Rezoning Transportation Analysis

Petition Number: 2018-118

Revision Log:	Date	Description
	10-12-18	First Review

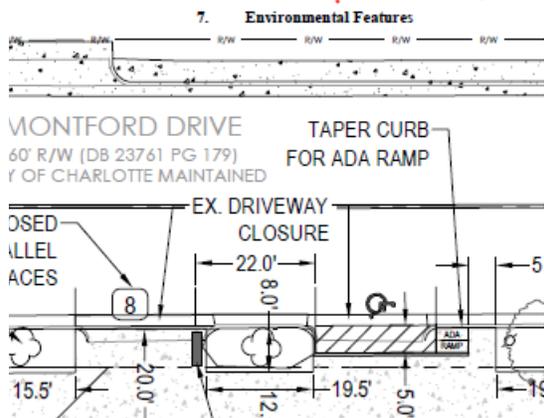
- The petitioner should revise the site plan and conditional note(s) to show amenity zone as approved in previous 2017-116 rezoning.

- The petitioner should revise the site plan and conditional note 5.e. to clearly state that the bench placement will not conflict with walkability of the sidewalk.
- The petitioner should revise the site plan and conditional note(s) to clearly show where on street ADA space will be as shown in previous rezoning 2017-116. PLEASE NOTE: ADA space does not have to be in same location as previous rezoning.

- The petitioner should revise the site plan and conditional notes to stub across access drive to the adjacent parcel (PID 17514501) per Transportation Policy T-4 in the Park Woodlawn Area Plan.
